ADDENDUM #1 for DFCM Project # 04036480- Building

PROJECT: JLTC – Building #1 (Building + Alternates) **DFCM Project # 04036480**
Camp Williams
Draper, UT 84065

FOOTING SCHEDULE

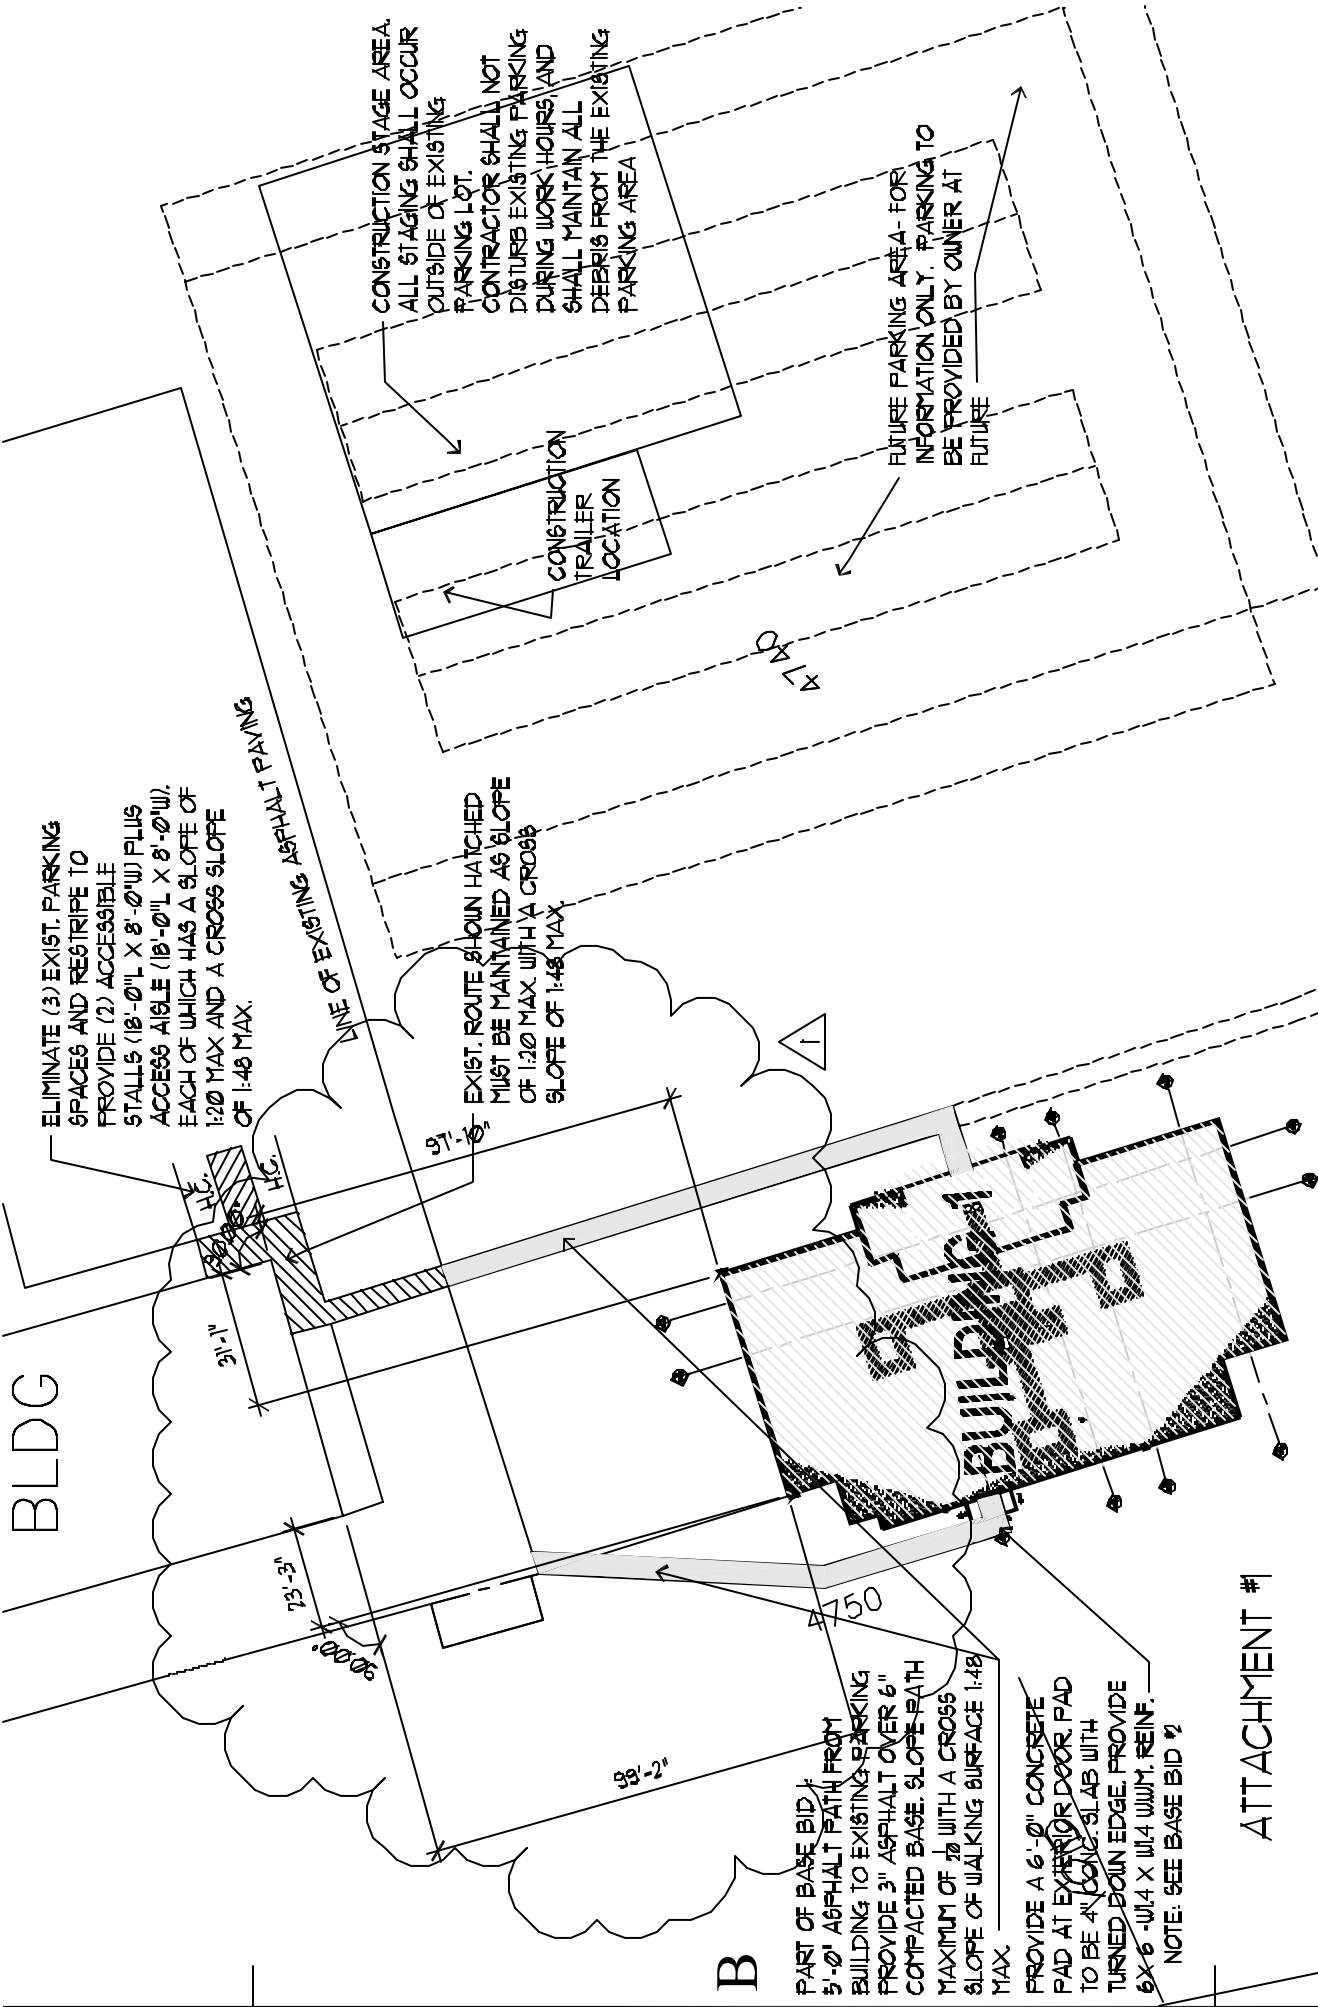
- 6. SHEET S-001 Structural Notes:
 - 6.1. See the attached notes on Special Inspections.
- 7. SHEET S-101 Footing and Foundation Plan:
 - 7.1. See the attached Footing Schedule.

ATTACHMENT #1

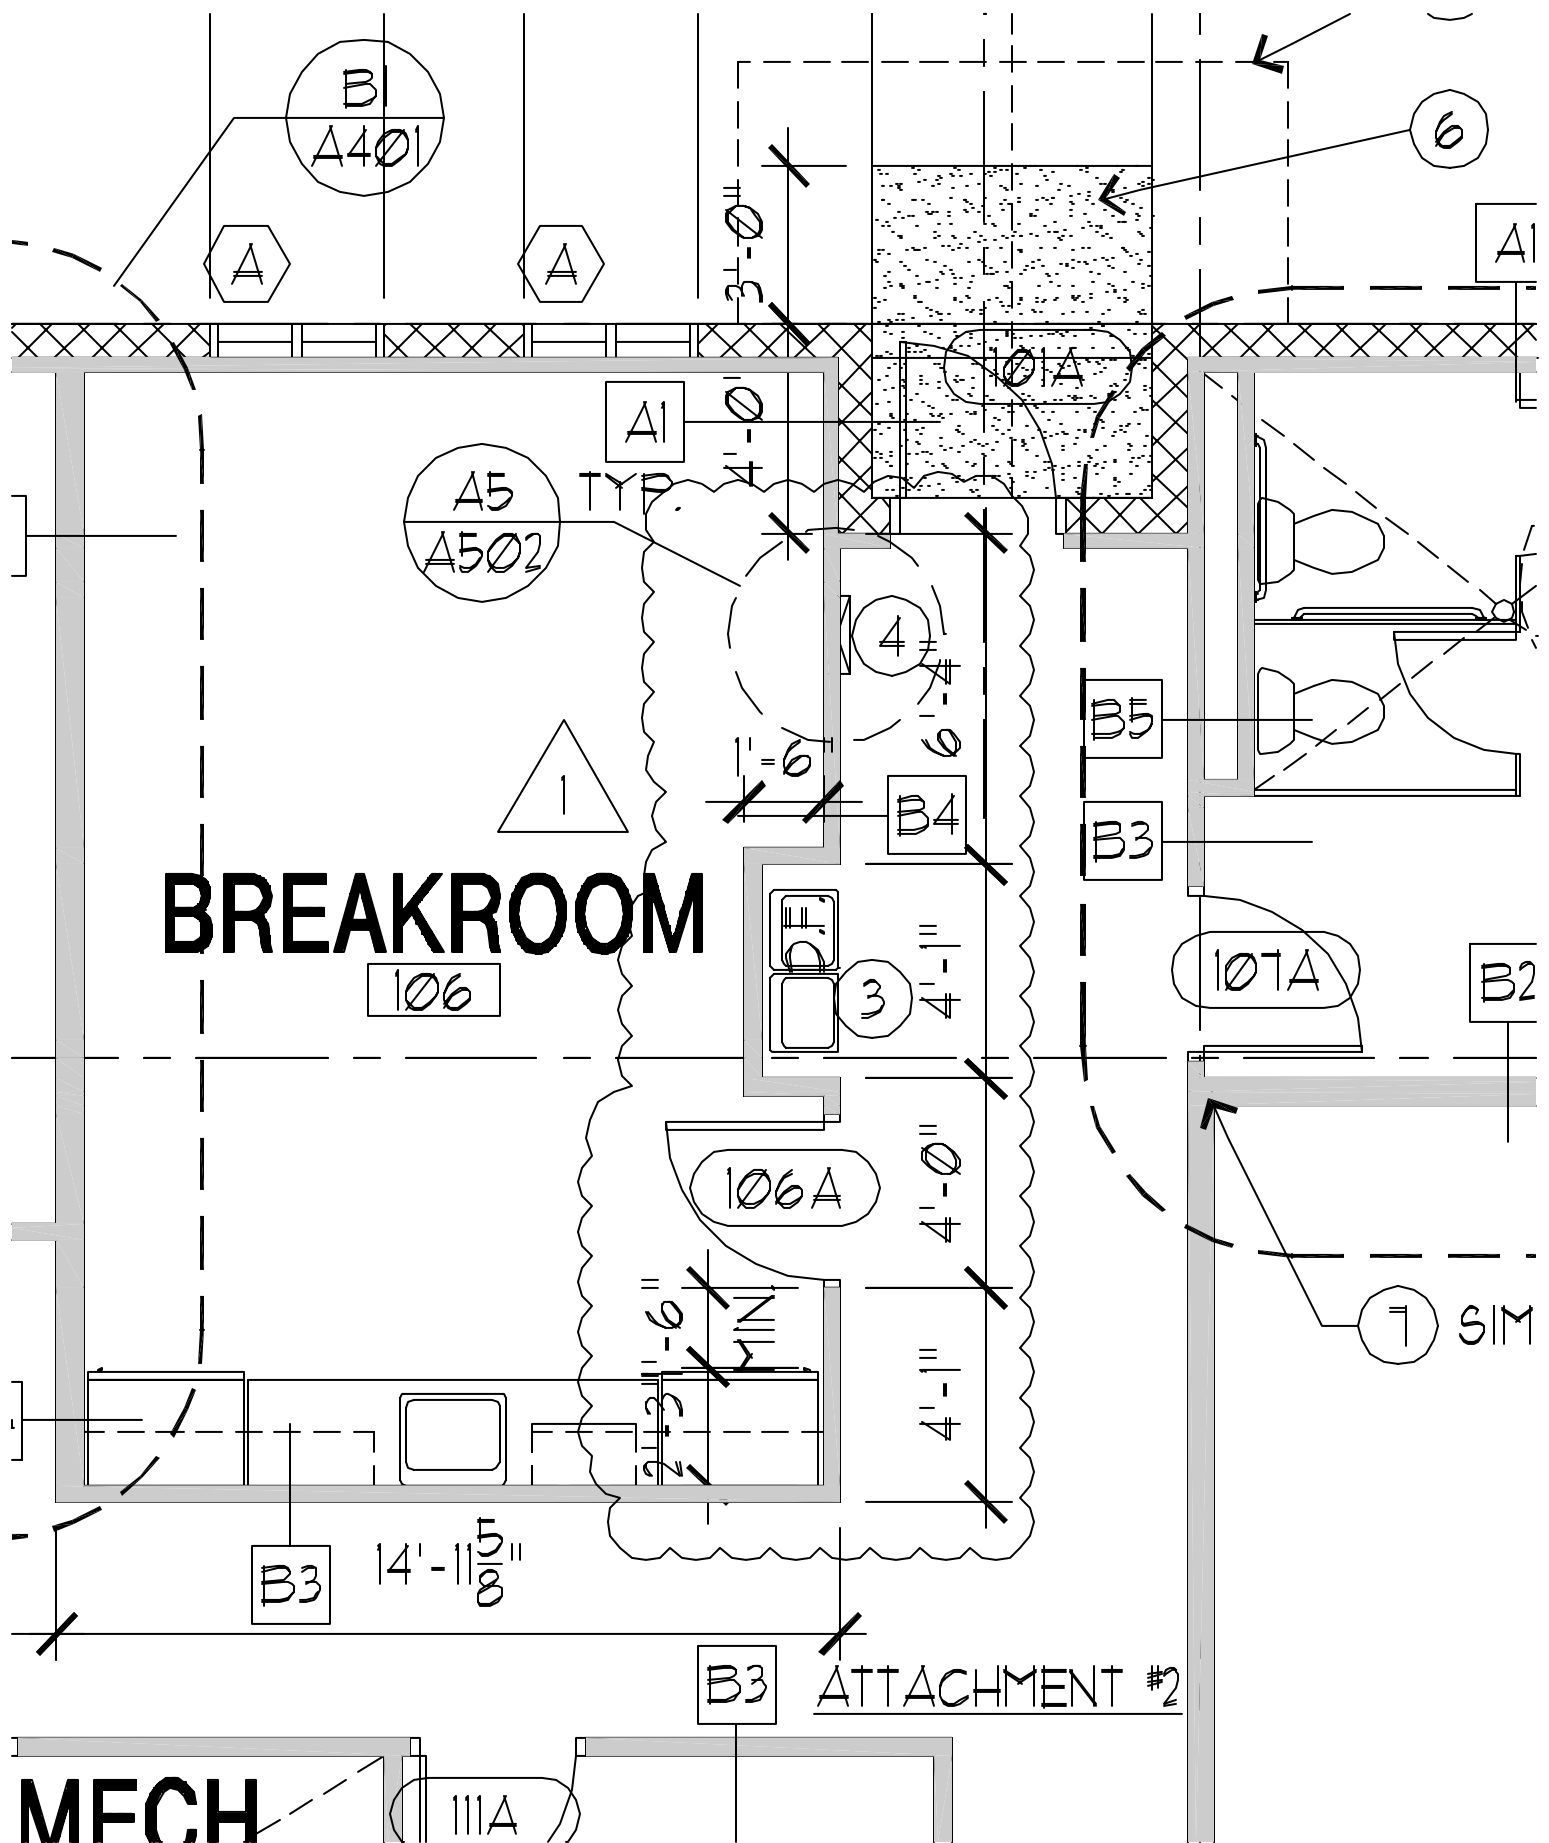
- 5. SHEET C-101 Civil Site Plan:
 - 5.1. Please note that this sheet other than what is noted to below is for reference and coordination purposes only as the work for this sheet is part of Base Bid #1.
 - 5.2. See the attached sheet #1 for building control data dimensions.
 - 5.3. See the attached sheet #1 for the revision of the concrete entry slabs that are part of Base Bid #2 and the asphalt walkways that are to be included in Base Bid #1. See sheet A-101 keynote #6 for information on the concrete entry slabs.
